Model: PC3000 Serial #: 1142 to 1160 and 300158 to 300349

Product Bulletin # GG

## Floor Panel Advisory

Figure 4: Decals on Removable Floor Panels

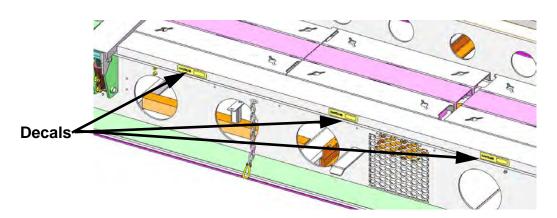
Affix lift-caution decals (Refer to Figure 3) on the c-channel beam on the main catwalk structure. Position the decals at the center of each floor panel as shown in Figure 4 and Figure 5. Contact RigLine 24/7™ Support to order the decals (Canrig P/N DT50459).
